City of Pasadena
Department of Water and Power

ADDENDUM NO. 3
to

Specifications LD-13-14
for

PROVIDING LABOR AND MATERIALS FOR
GLENARM REPOWERING BALANCE OF PLANT DESIGN AND CONSTRUCTION

JOB NUMBER	REV
123374	H
DRAWING NUMBER	
M3-3-2

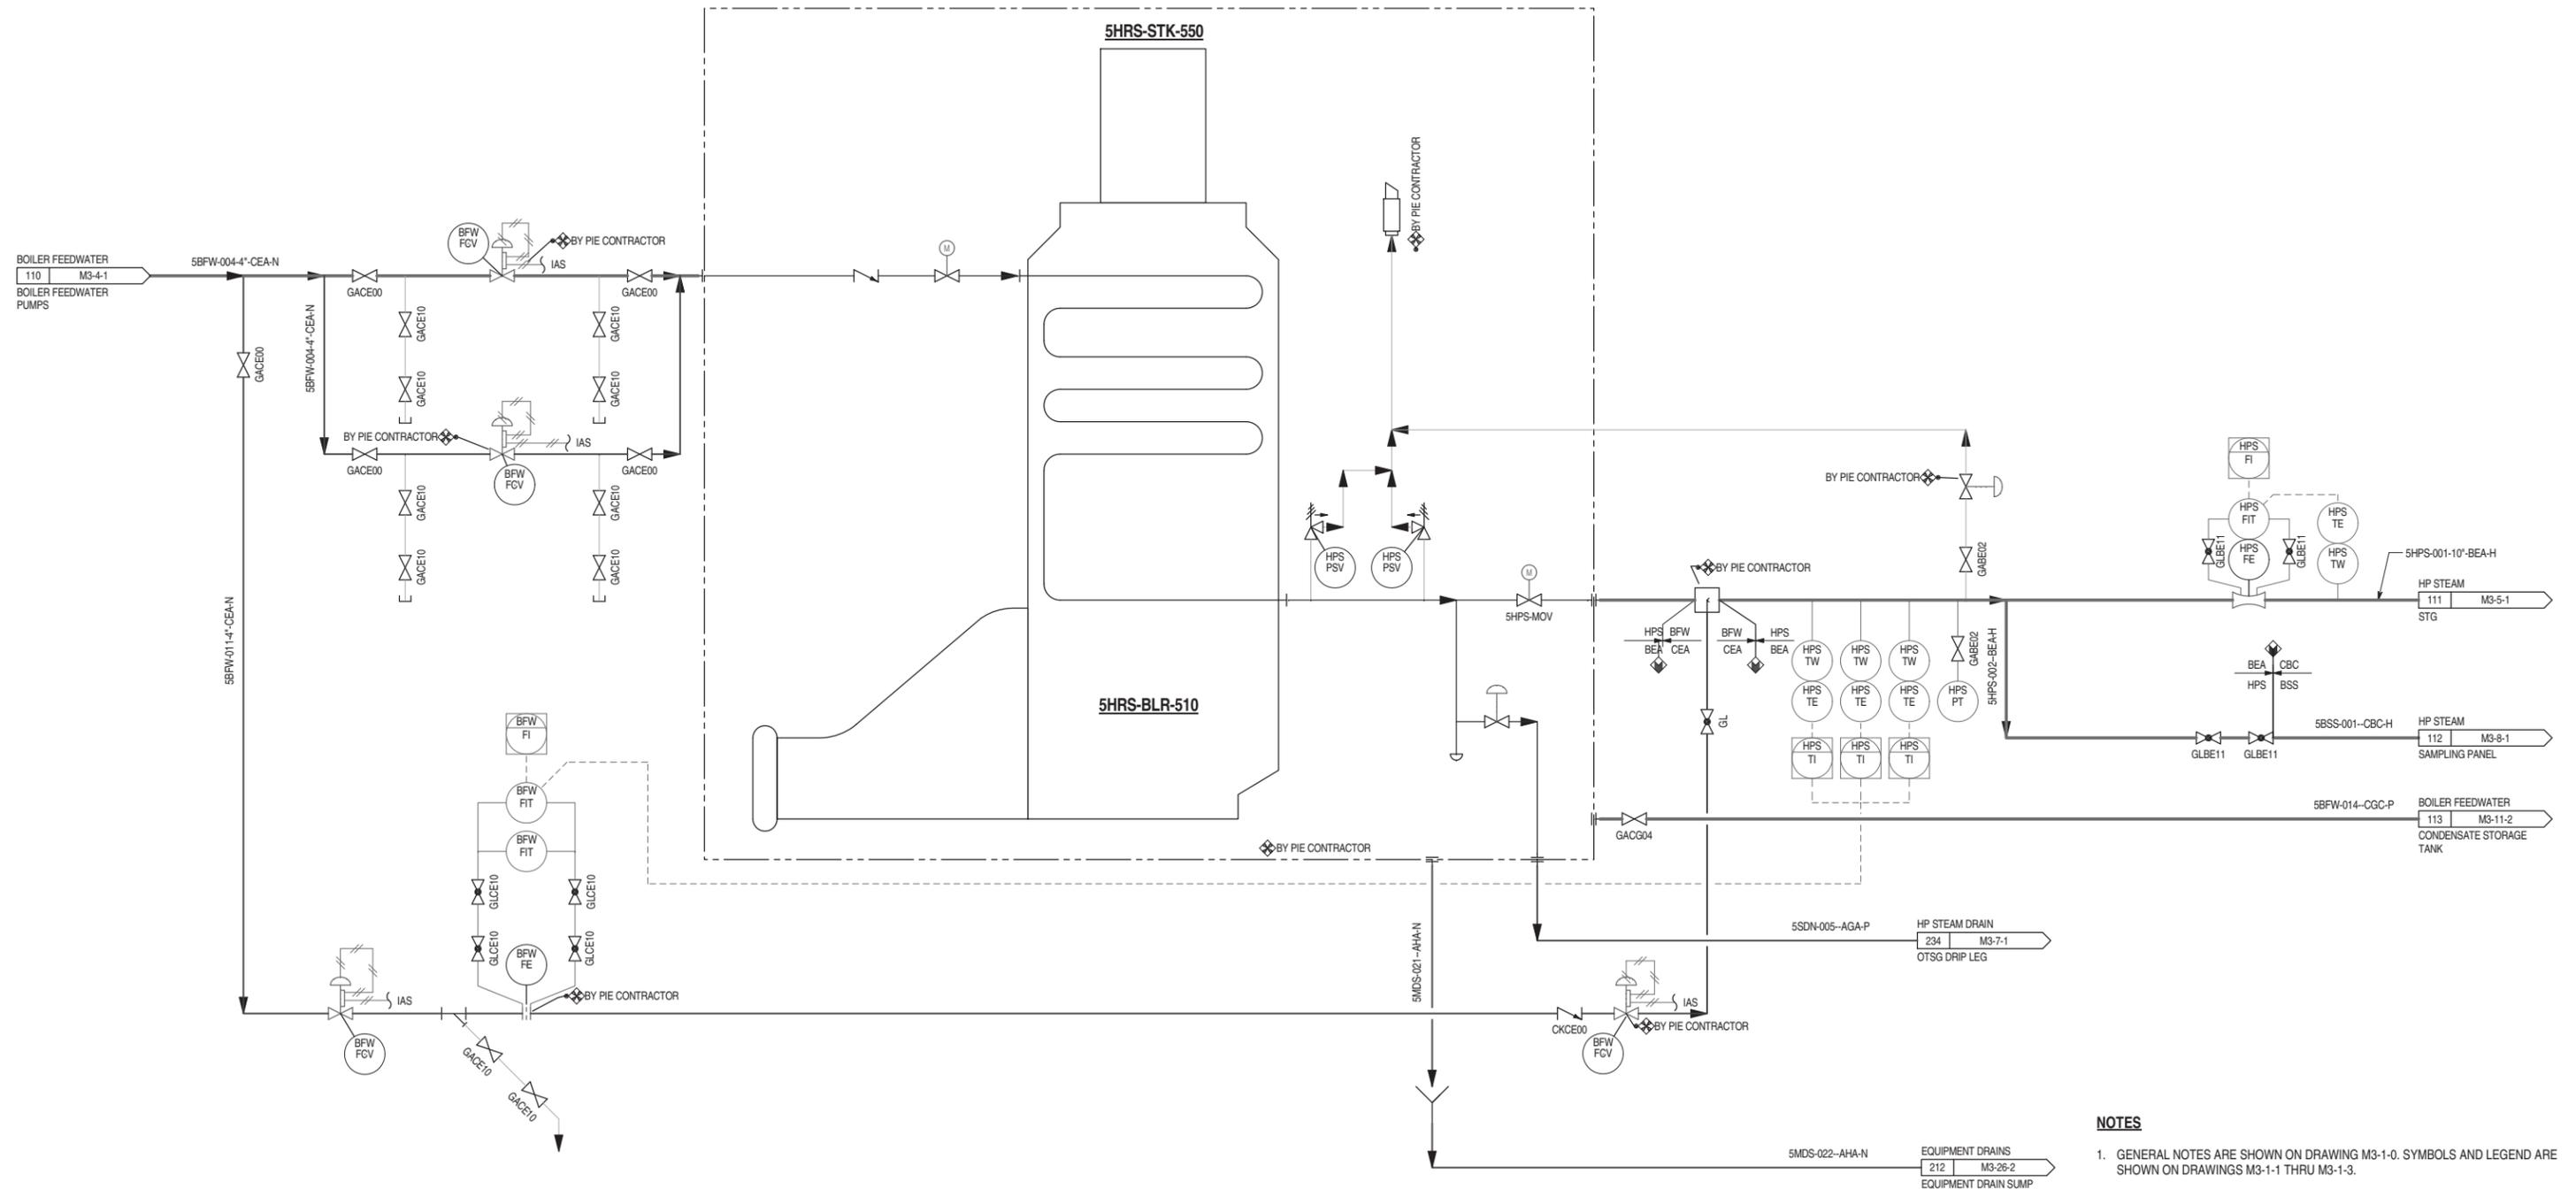
7. Notice that the inlet air heating portion of the combustion turbine chiller system has been deleted. Replace P&IDs M3-3-2, M3-11-1, M3-11-2, M3-13-1, M3-25-1, and M3-25-2 from the Preliminary Drawings in the BOP Scope of Work Attachment A.2.D. See Enclosure 5.

An electric heater has been added to heat the chiller fluid for anti-icing protection.

Prepared by:
SAA Associates
January 15, 2014

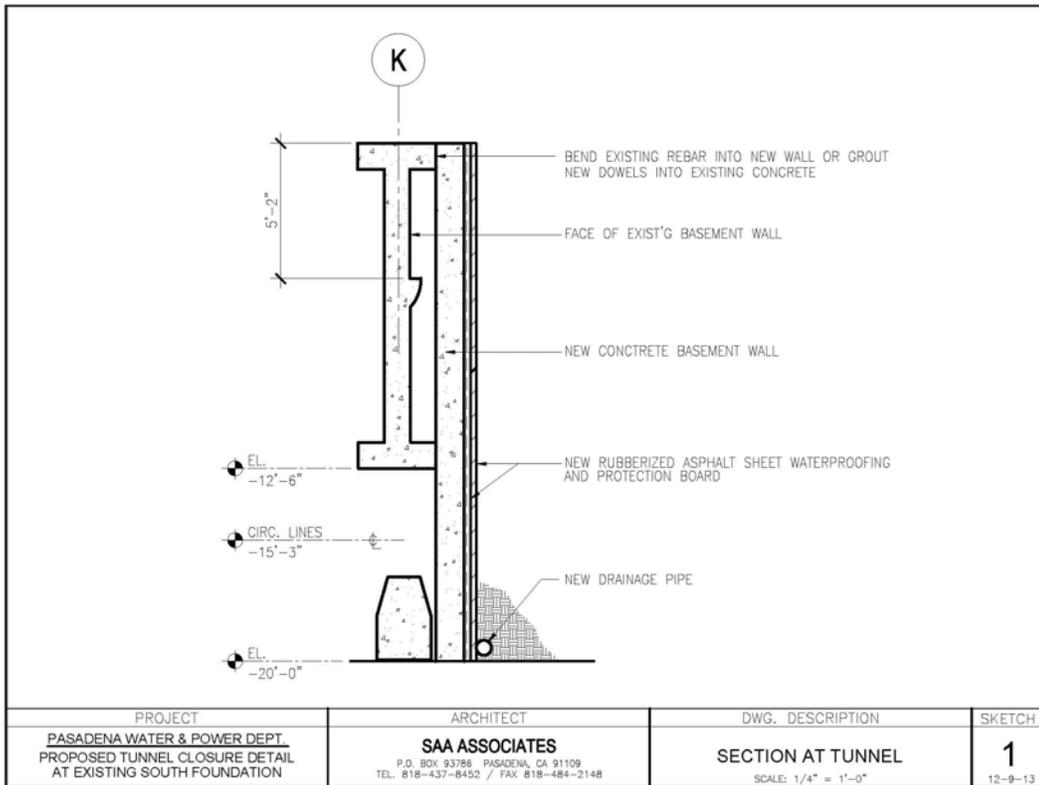
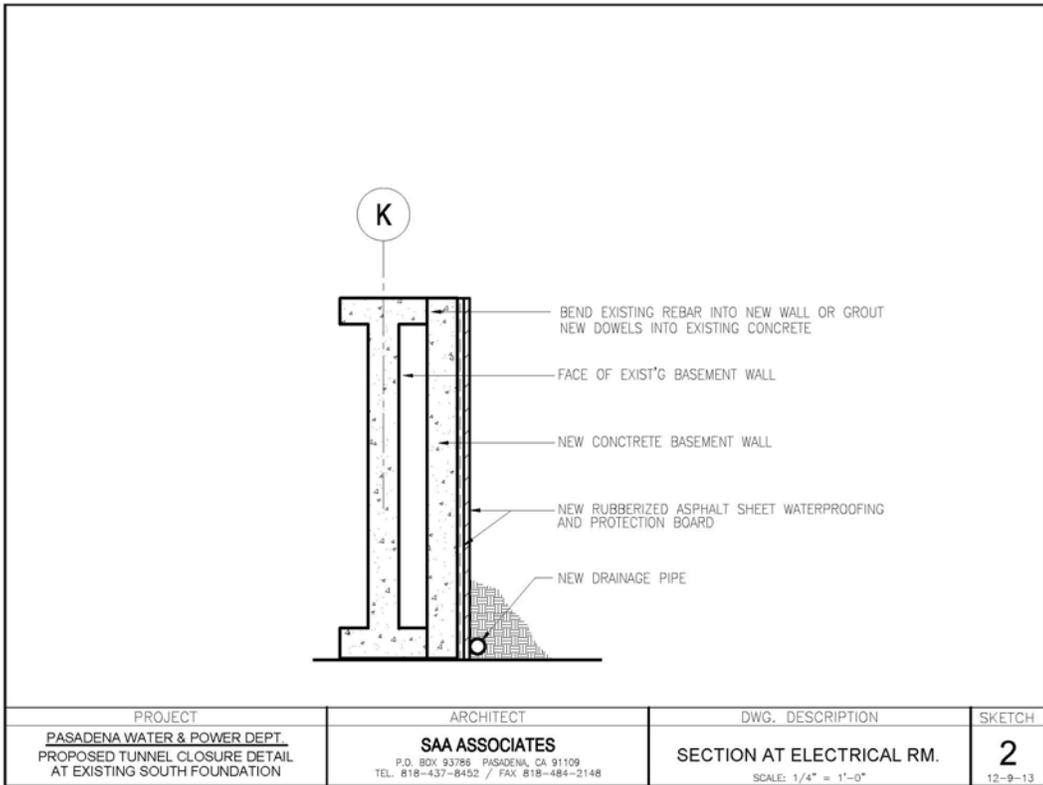
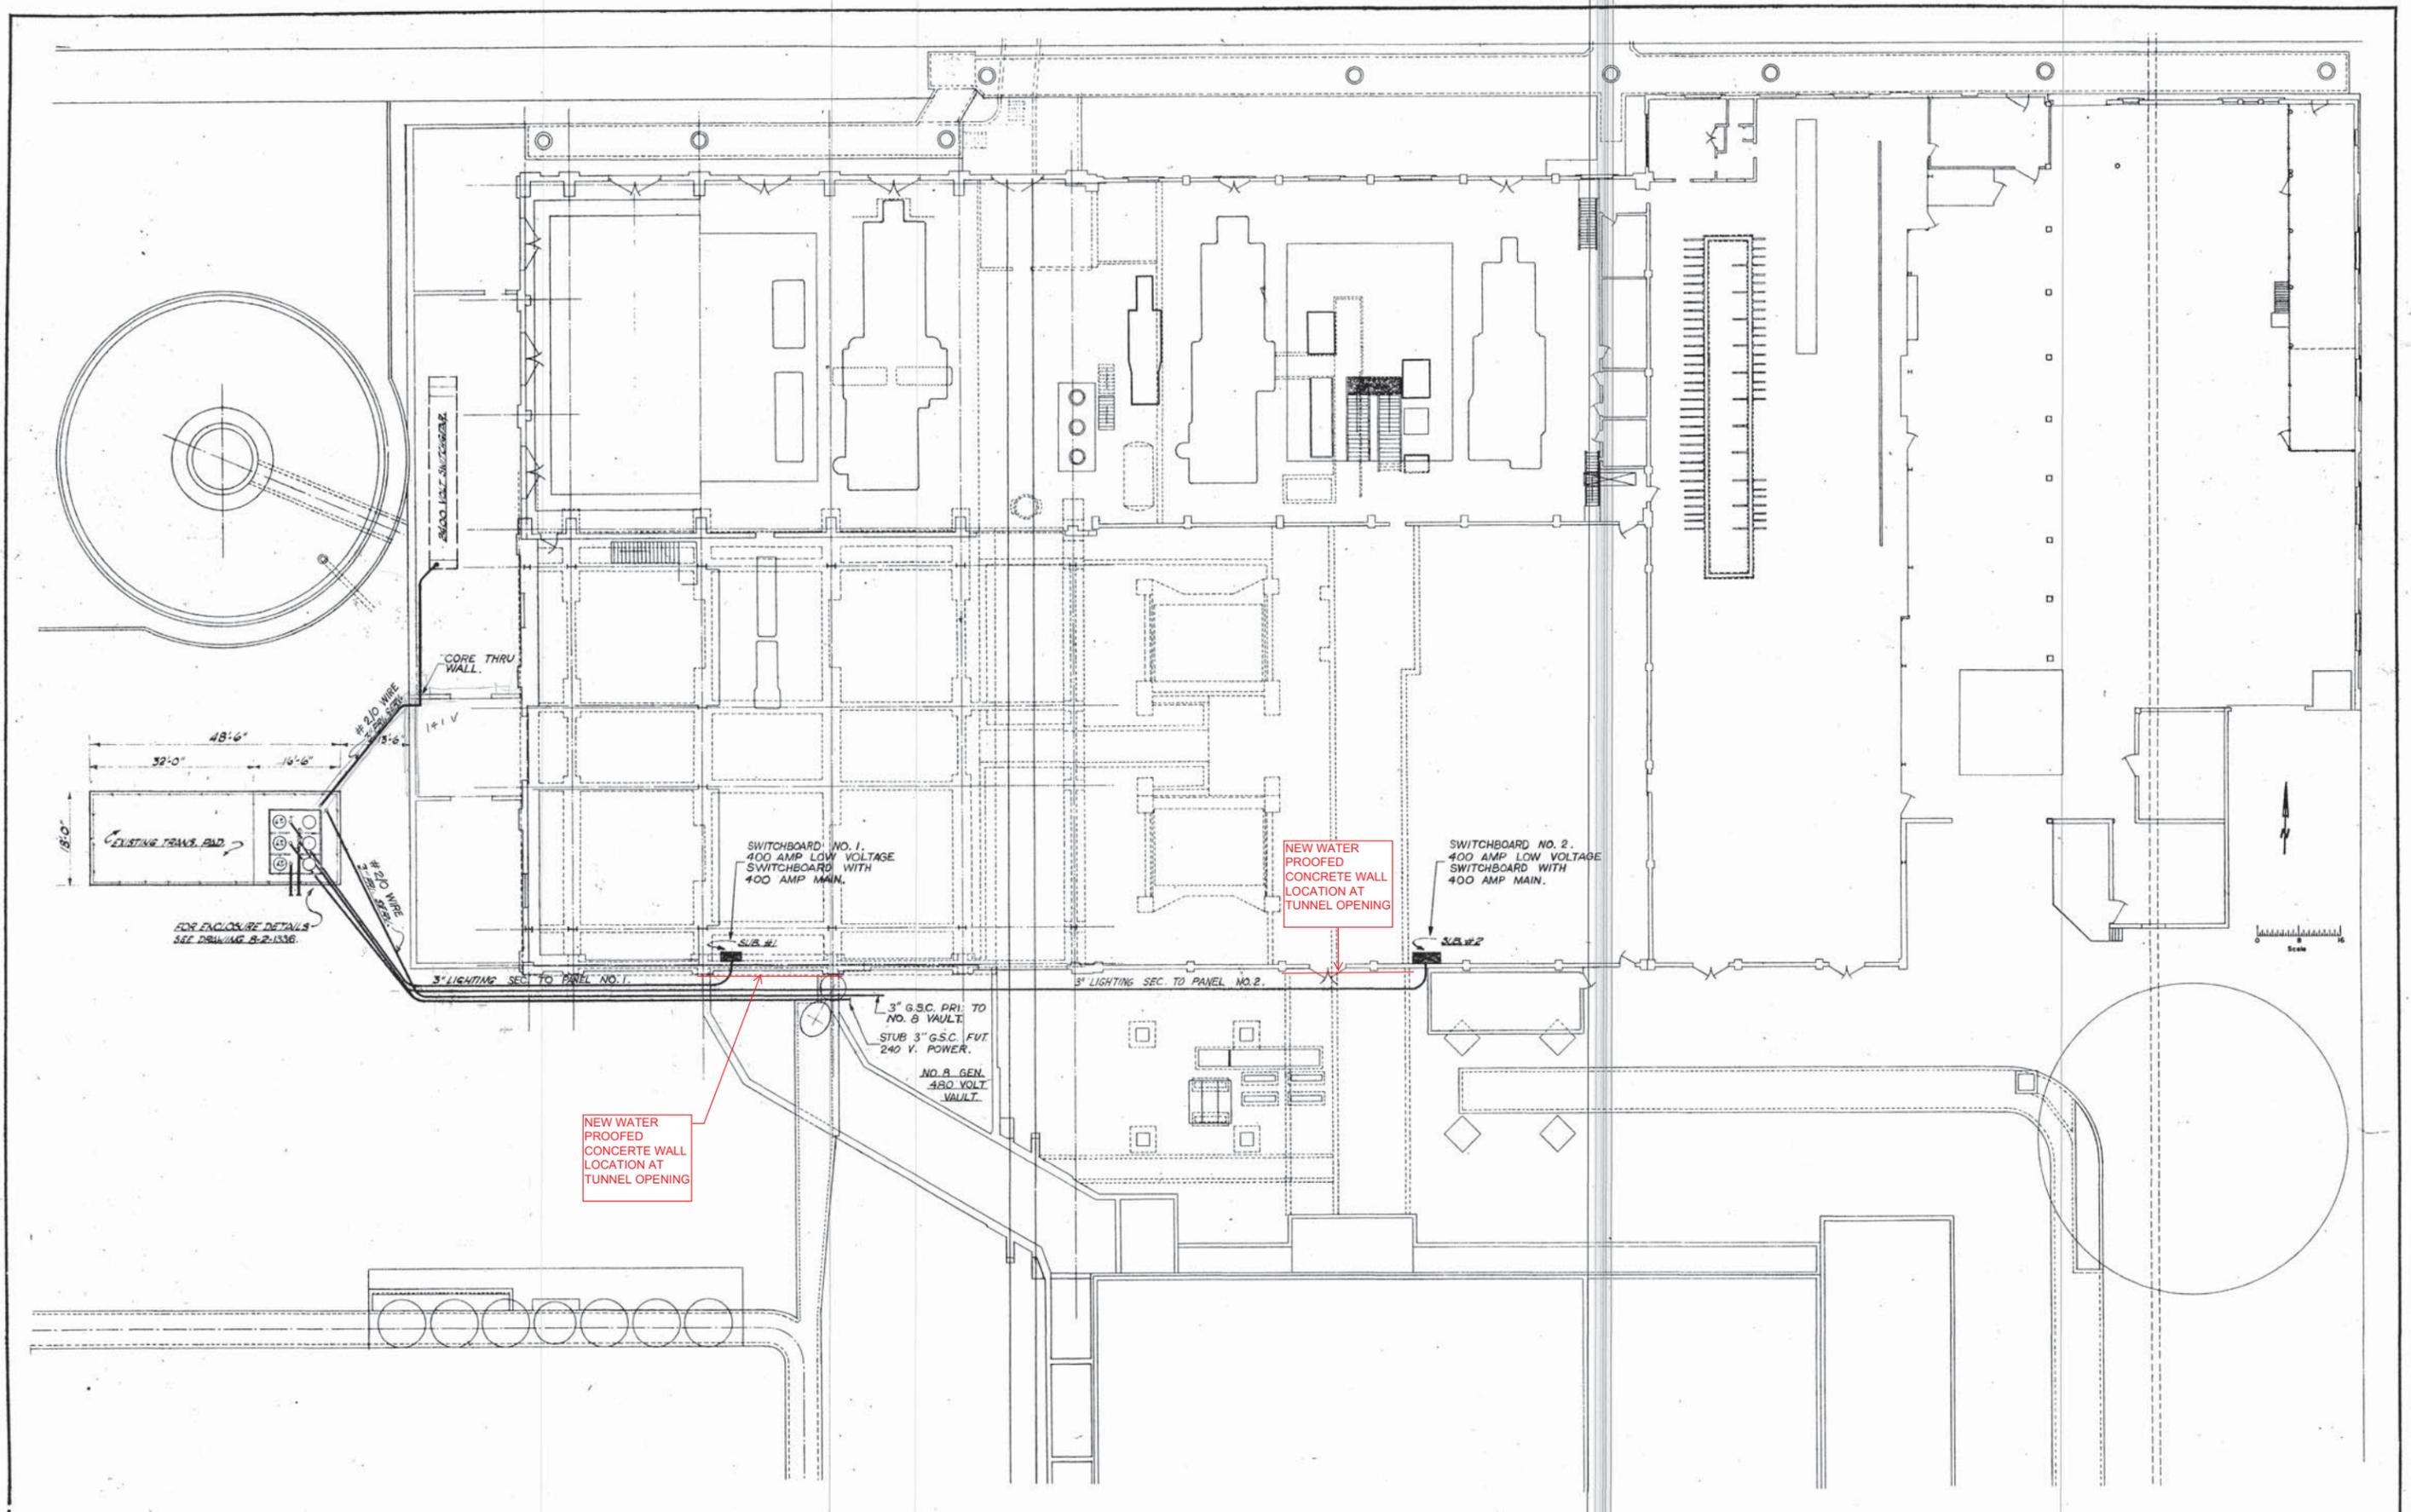
8. New concrete wall shall terminate at least two feet (2'-0") past tunnel openings to be sealed at each end. This condition shall define the maximum length of the new concrete wall.

9. Develop design and construction drawings for review and approval by the City prior to the commencement of construction work.
10. Develop a schedule for this scope of work and identify critical preceding and subsequent activities that will have schedule and or cost impact for review by the City.

11. Coordinate, determine and obtain all required agency approvals including, but, not limited to permits, inspections and associated payment of fees.
12. Provide shoring design/construction required to facilitate the implementation of the new wall.
13. Provide a unit cost for each type of wall.
14. Provide confirmation whether the Prime Contractor will self perform this scope of work. If not, please submit subcontractor questionnaire identifying which entity will perform this work
15. Submit a component cost for the design and construction of this scope of work.

“Refer to the “Statement of Work for Design and Construction of New Concrete Wall to Seal Existing Tunnels at South Wall of Glenarm Power Plant Building January 15, 2014”, contained in Addendum #3 Enclosure 7. The BOP Contractor shall prepare detailed design drawings for submission to the Building Department as part of the Building permit. The BOP Contractor shall not commence wall construction without approval of the Building Department.”
